**• A D D E N D U M # 2 •**

<b>TO ALL PLAN HOLDERS</b>	<b>DATE</b>	<b>JULY 10, 2015</b>	<b>JOB NO.:</b>	<b>2302-023</b>
	<b>ATTN</b>	<b>Plan Holders</b>		
	<b>RE</b>	<b>City of Newport Ferry Slip Road Improvements</b>

PLAN STA 0+00 TO STA 4+00

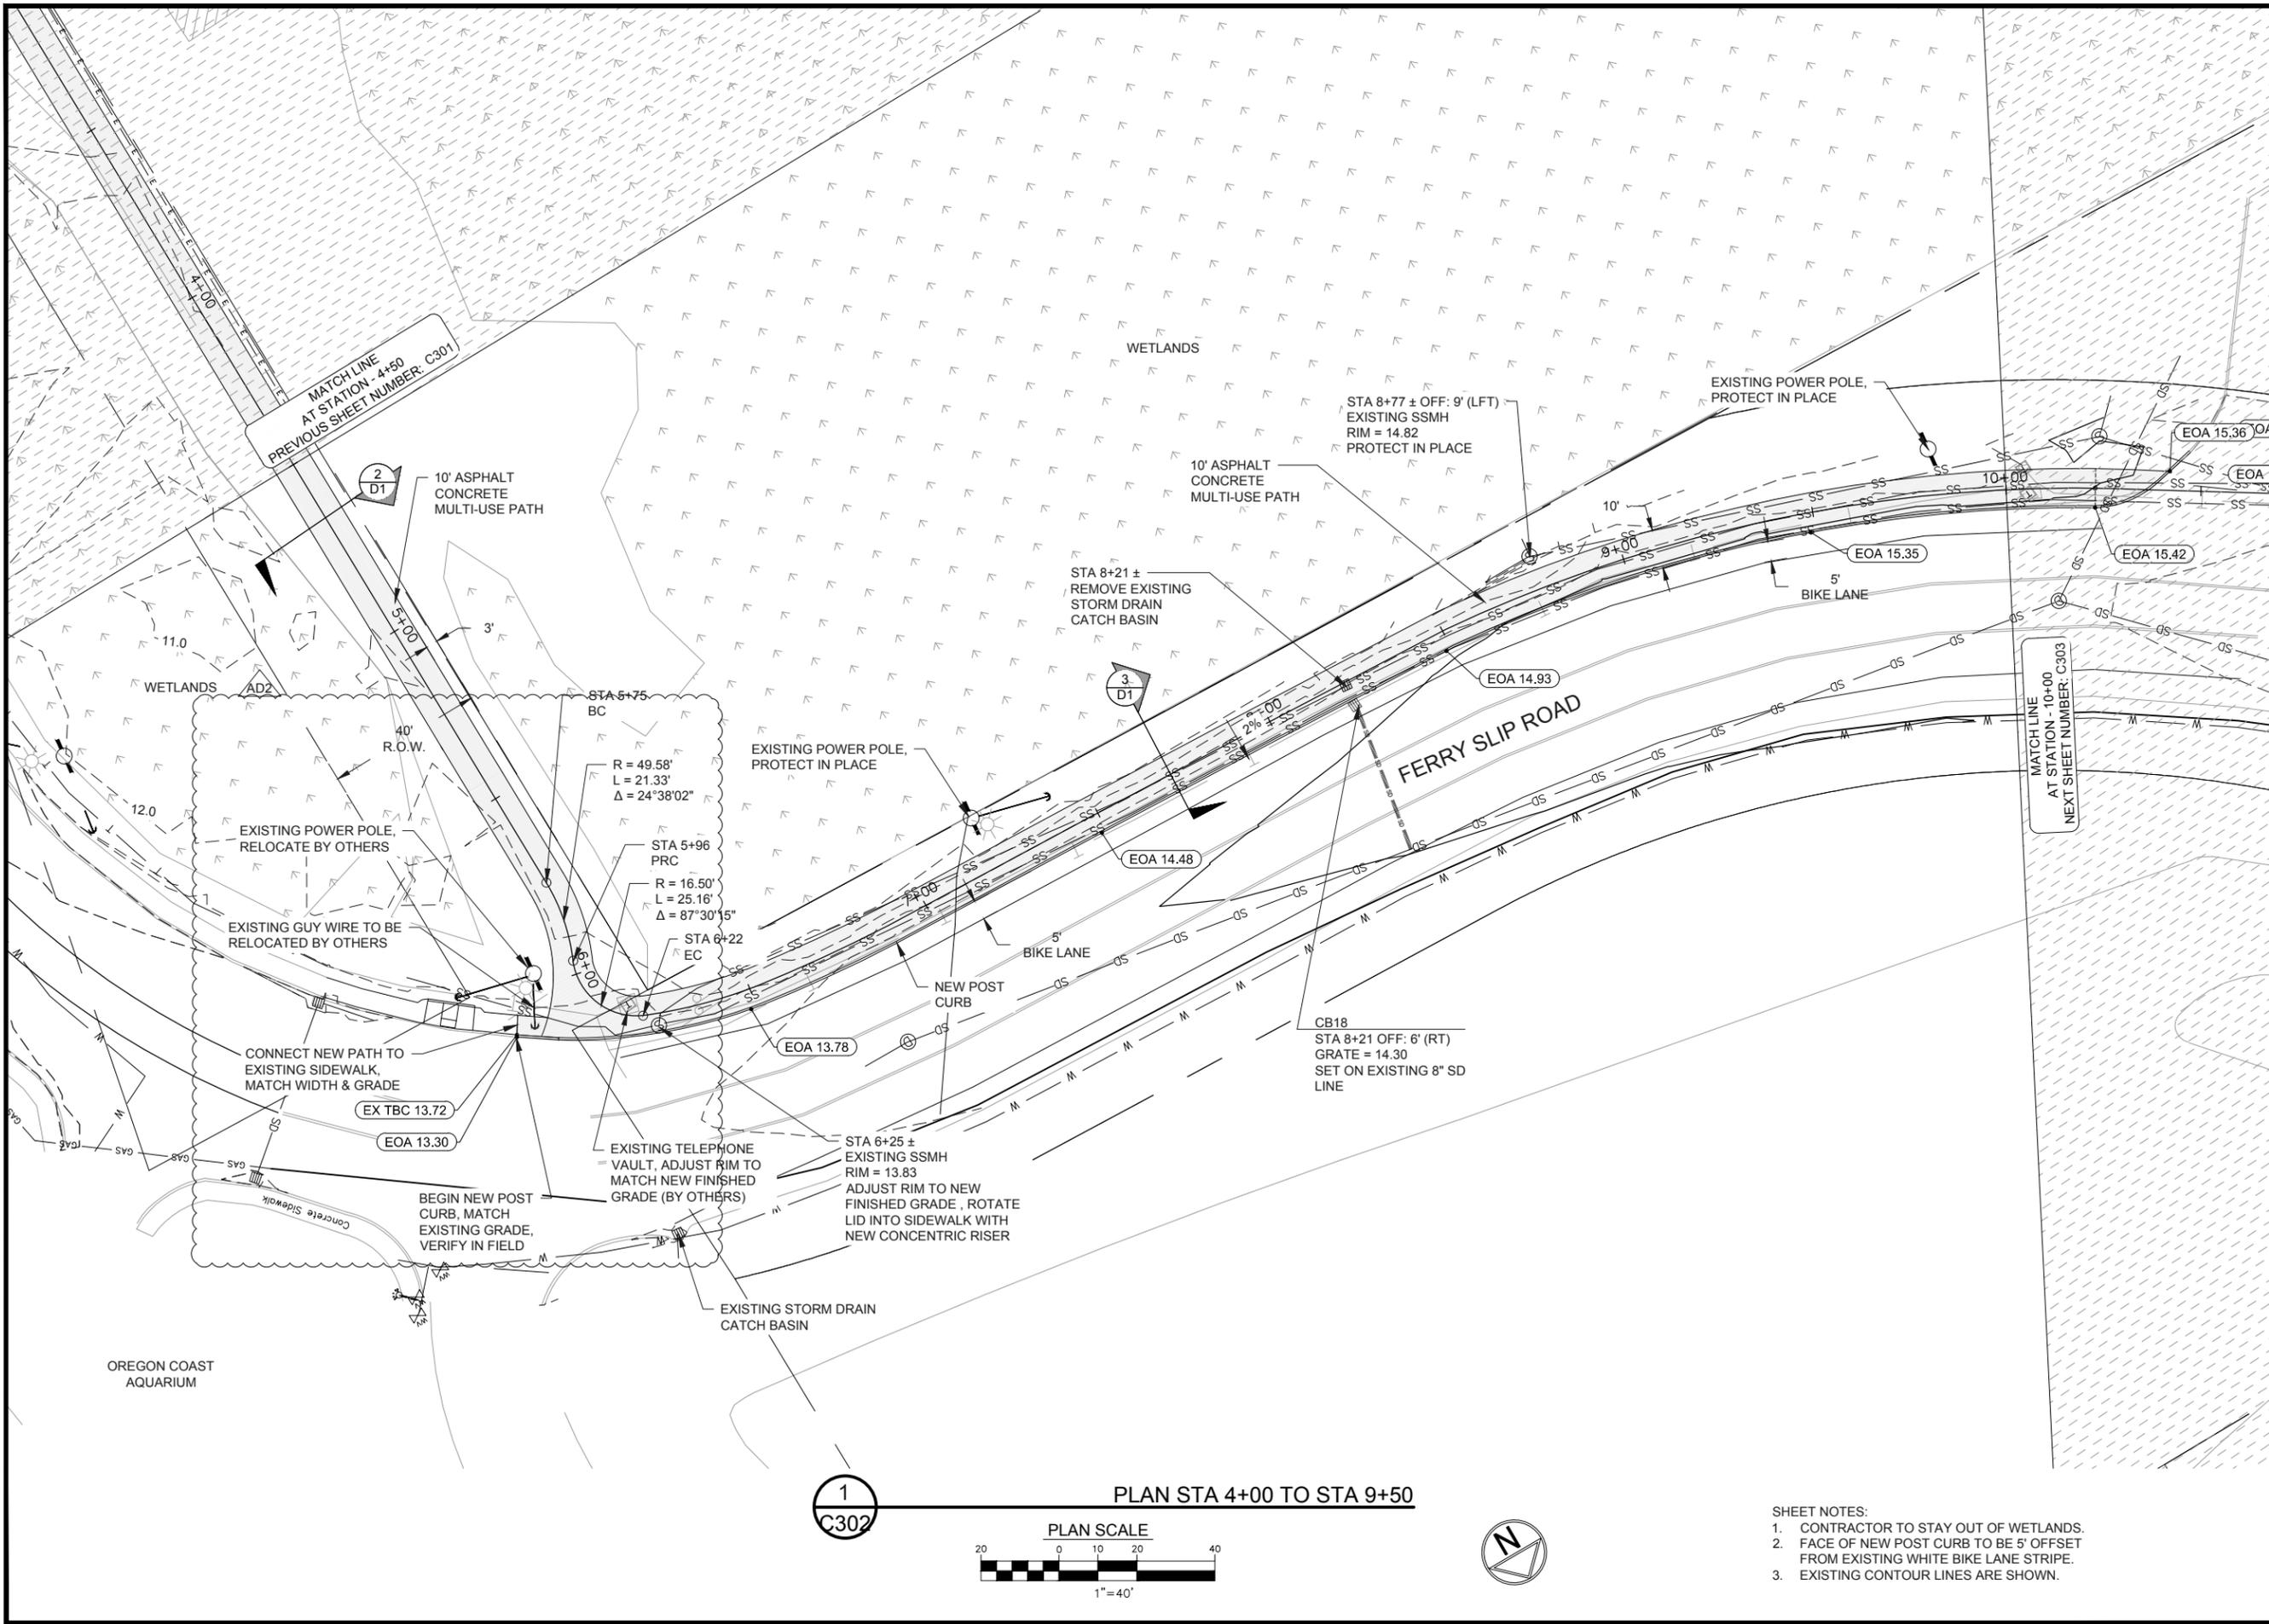
20. C301- Change Parking at 32<sup>nd</sup> Street Pump station parking lot from "4"-1 1/2" Agg Base Gravel Surfacing to 3" AC surfacing.
21. C302- Remove Trail route around existing power pole and tie trail directly into existing sidewalk.
